# Access Compliance Report

## Public Rights-of-Way

Intersection ID: 50511	Main Street: ALLEN_A_BROWN_RD	Cross Street: MERIDALE_CROSSING_DR	Location: E
ADA ID: 7AB511ACBFF7	Ramp Type: PerpDiag	Initial Pass/Fail: Fail	Overall Compliance: No
Severity Score: 0			
Codes/Mitigation Info/Possible Solution		Field Measurements/Component Compliance

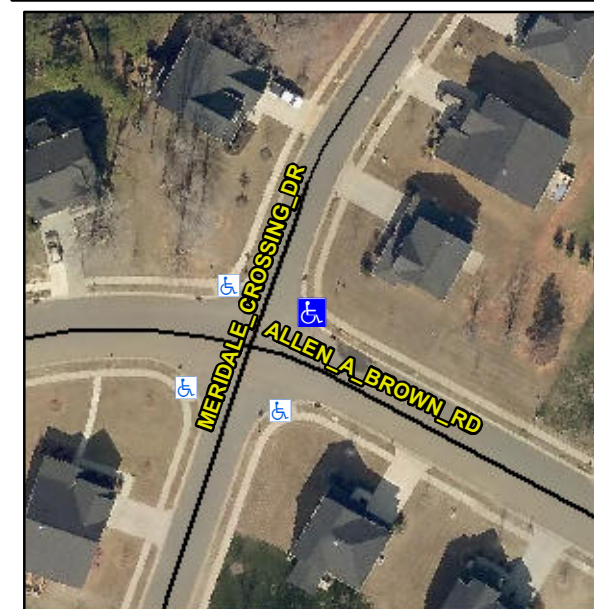
Compliance	Description	Data	Compliance	Description	Data
N/A	Ramp Length (in)	48.0	Yes	Ramp Slope (%)	5.9
Yes	Ramp Width (in)	48.0	Yes	Ramp XSlope (%)	0.1
N/A	Flare Type LT	N/A	N/A	Flare Type RT	N/A
N/A	Flare Slope LT (%)	N/A	N/A	Flare Slope RT (%)	N/A
N/A	Flare Traversable LT?	N/A	N/A	Flare Traversable RT?	N/A
N/A	Landing Length (in)	N/A	N/A	DWS Provided?	N/A
N/A	Landing Width (in)	N/A	N/A	DWS Contrast?	N/A
N/A	Landing Slope (%)	N/A	N/A	DWS Length (in)	N/A
N/A	Landing X Slope (%)	N/A	N/A	DWS Full Width?	N/A
N/A	Landing Curb? (Y/N)	N/A	N/A	DWS Offset (in)	N/A
N/A	Shared Landing?	N/A			
N/A	Gutter Ponding?	N/A	N/A	Gutter Slope (%)	N/A
N/A	Gutter Lip Ht (in)	N/A	N/A	Gutter X Slope (%)	N/A
N/A	Painted X Walk1?	No	N/A	Painted X Walk2?	No
	X Walk 1 Direction	To NW		X Walk 2 Direction	To SW
N/A	X Walk 1 Width (in)	N/A	N/A	X Walk 2 Width (in)	N/A
	X Walk 1 Slope (%)	1.5		X Walk 2 Slope (%)	0.7
	X Walk 1 X Slope (%)	0.9		X Walk 2 X Slope (%)	2.0

N/A	Ramp inside XWalk1?	N/A	N/A	Ramp inside XWalk2?	N/A
	Road Slope (%)	0.3	N/A	Clear Space?	N/A
	Road X Slope (%)	1.1	N/A	Clear Space to XWalk (in)	N/A
N/A	Any Obstructions?	N/A	N/A	Storm Grate/Utility Hazard?	N/A
	Obstruction Type			Storm Grate/Utility Type	
		N/A			N/A
		Yes		Surface Condition? (G/P)	Good

**Remove & Replace Curb Ramp With Two New Directional Ramps or Equivalent.**
